Work Order ID 126214

Item ID: 41228-301-063-002

Item Name: Fuel Return Cavity, RH

41228-301-063-002 CAVITY		41228-301-063-001 CAVITY							
PART NO.		NAME		STOCK SIZE		MATERIAL		MATL. SPEC.	
NO. REQ'D PER ASSY.		LIST OF MATERIAL		T. HARVILLE		2/15/95		TITLE	
PROPRIETARY RIGHTS NOTICE		UNLESS OTHERWISE SPECIFIED		CHECK		STRESS		FUEL RETURN CAVITY	
X ± .1		XX ± .03		XXX ± .010		FINISH		DWG. SIZE C	
1		41228-301-065		NEXT ASSEMBLY		ERA HELICOPTERS LLC		DWC. NO. 41228-301-063	
								REV. D

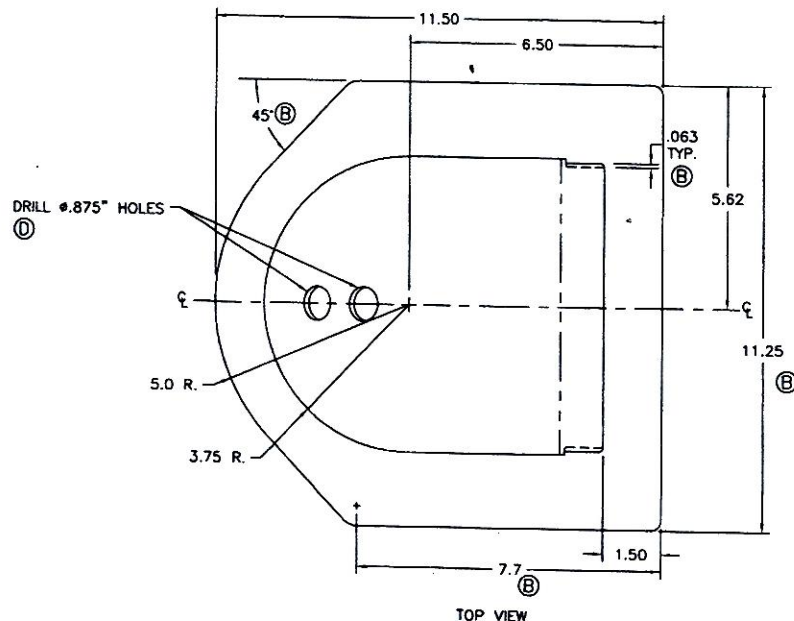
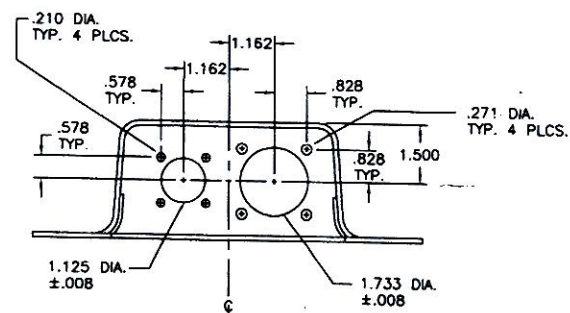
Root Cause		Date	Step	Qty	Description of work order update or non-conformance	Initial Chief Eng	Action Description	Sign & Date	Verification	QC Inspector
Design		150601	140	①	Dimension out of tolerance • 1.733 is 1.800 • 1.125 is 1.160 • .815 is .915 • 2.93 is 3.180	DAS 12 9-89 15/6/9	Acceptable see att. email Acceptable for testing	DAS 12 9-89 15/6/9	PD 15-02-02	PD 15-02-02
Doc/Data										
Equip/Tooling										
Handling/Pre										
Material										
Operator										
Offset/Setup										
Process										
Supplier	✓									
Training										
Transport										
Unapproved

I'm pretty sure that that 3.1 dim matches with a part that goes over top of the end of that part you are referring to. I'm concerned that it won't fit properly if we let it go that big?

Does this part (with its deviations) fit with the next part in the system? That would be my biggest concern.

I wanted to know if you allow some deviations on some dimension of 41228-301-063-002.

- 1.733 is 1.800
- 1.125 is 1.160
- .675 is .915
- 2.93 is 3.180

I guess my concerns are unfounded. Good to go then

Me and kevin test fitted D5239-1 on the cavity and its actually fits good.
I've attch picture, let me know what you thing
